SERIAL: HNP-11-079

SHEARON HARRIS NUCLEAR POWER PLANT, UNIT NO. 1  
DOCKET NO. 50-400/RENEWED LICENSE NO. NPF-63  
RESPONSE TO REQUEST FOR ADDITIONAL INFORMATION  
REGARDING MEASUREMENT UNCERTAINTY RECAPTURE  
POWER UPRATE LICENSE AMENDMENT REQUEST

Enclosure: Response to Request for Additional Information

**Figure 1. MVAR Capability and Generator Nameplate Requirement Example**

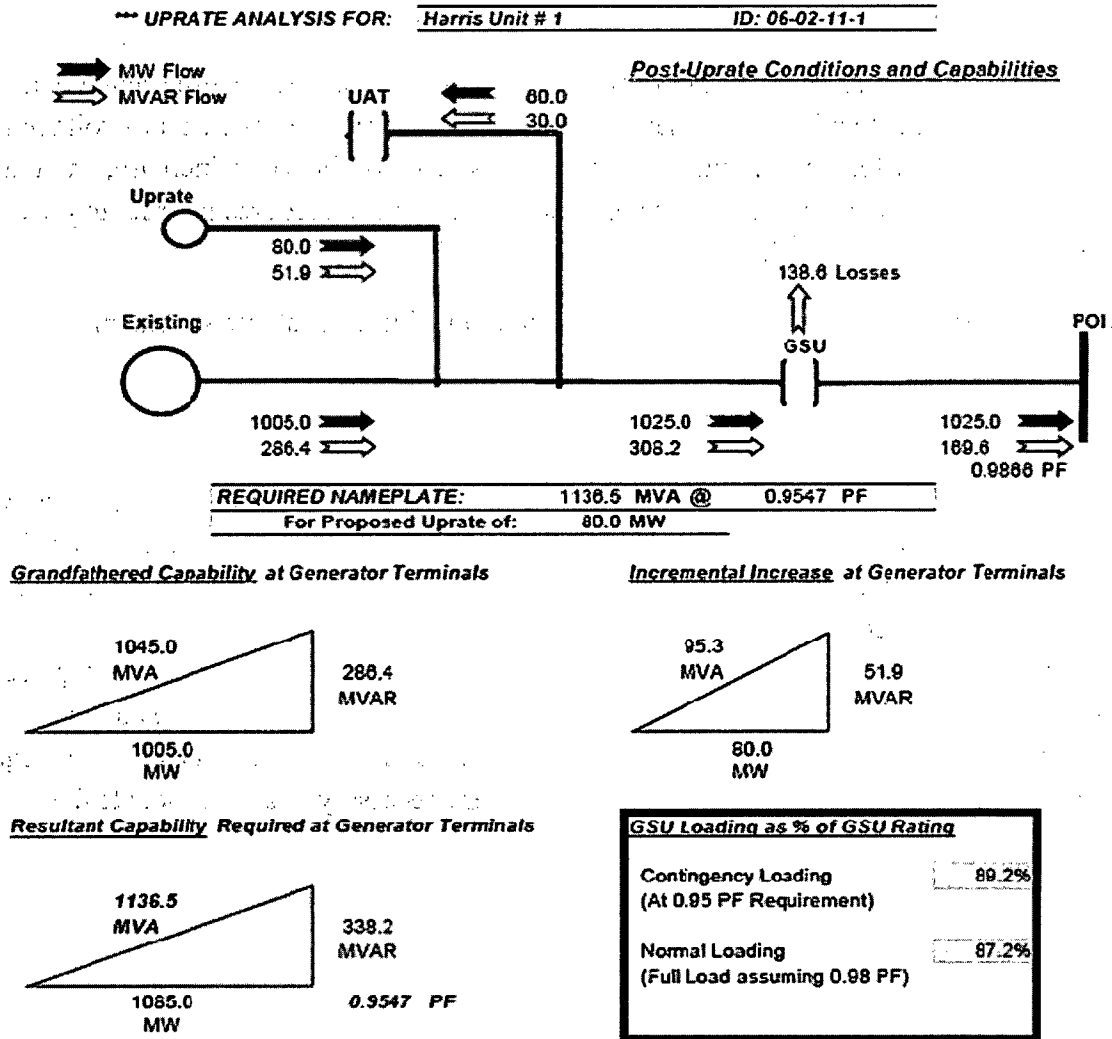
In Enclosure 2, Section V.1.D, "Grid Stability – Large Generator Interconnect Power Factor Requirement," the licensee stated that for a 66 Mega Watt electric (MWe) increase on HNP Unit 1, a generator nameplate rating of 1155 Mega Volt Ampere at 0.94 Power factor lagging was required.

Provide a summary of the calculation that confirms that the capability of the replacement main generator will bound the MVAs Reactive requirement corresponding to the 66 MWe increase.

PEC Transmission Planning determines the MVAR requirement for generation additions, including MW increases of existing generators. The requirement is that the generation must be capable of delivering the additional MW output to the point of interconnection (POI) at a 0.95 lagging power factor. For an existing generating unit which is being uprated, this requirement applies only to the MW increase. The existing MW output of the unit is grandfathered at the unit's present MVAR capability or a MVAR capability equivalent to 0.95 lagging power factor at the POI, whichever is less. This information is used to determine what the required generator MVA/Power Factor nameplate must be to meet the MVAR capability requirement. Figure 1 below illustrates how this was done for the HNP MUR power uprate 66 MW increase. The *Grandfathered Capability* is shown as a power triangle for the original generator, rated at 1045 MVA. Using the 1045 MVA and the maximum gross MW output prior to uprate (1005 MW) yields a grandfathered MVAR capability of 286.4 MVAR. By agreement between HNP and Transmission Planning, an *Incremental Increase* of 80 MW was assumed to allow some margin over the proposed 66 MW increase. This 80 MW was used only for purposes of calculating the MVAR requirement and generator nameplate requirement. Using the 80 MW increase, an additional 51.9 MVAR would be required at the generator terminals. This value takes into account the additional losses in the main (step up) transformer, referred to as *GSU* in Figure 1, due to the increase. The *Resultant Capability* triangle is the geometric sum of the *Grandfathered Capability* and *Incremental Increase* triangles. From the *Resultant Capability* triangle, a generator nameplate of 1136.5 MVA at 0.9547 power factor is required. Based on this, the actual installed generator nameplate was chosen to be 1155 MVA at 0.94 power factor. As can be seen in the figure, this does not mean that the entire MW output of the unit conforms to the 0.95 lagging power factor at the POI requirement.

LEFM Electrical Load Description

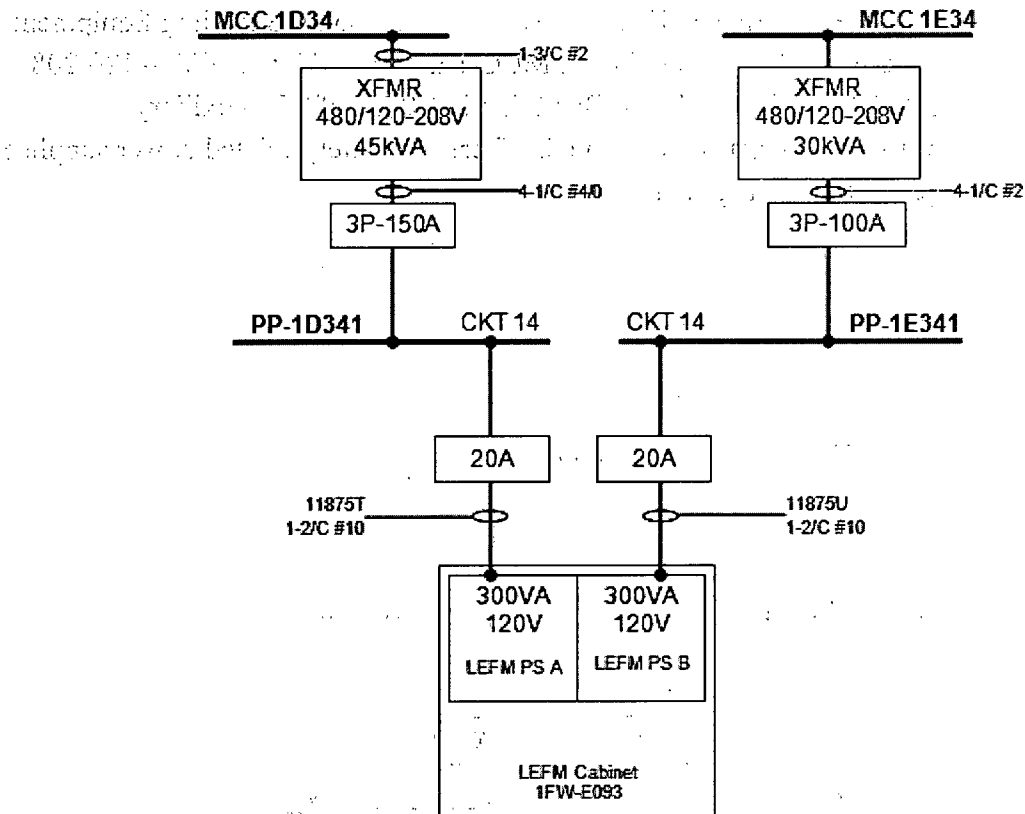
Provide a discussion on the auxiliary power requirement for the Cameron Leading Edge Flow Meter CheckPlus System, such as direct current or AC power requirements, and its loading impact on the associated safety-related or non-safety-related bus.

The LEFM CheckPlus System consists of an electronic cabinet installed in the Secondary Sampling Equipment Enclosure located in the Turbine Building, and measurement spool pieces installed in each of the three main feedwater lines. Two 120 VAC, single phase, 60 Hz power sources are supplied to the LEFM CheckPlus system.

The LEFM Check Plus system is not required to function during a postulated accident or event. Therefore, the system uses non-safety power sources, and emergency diesel generator loading is unaffected. There are two independent measurement systems (A and B) in one cabinet. Each measurement system has its own independent power supply. Each power supply is fed by a separate circuit from a separate power source to maintain independence.
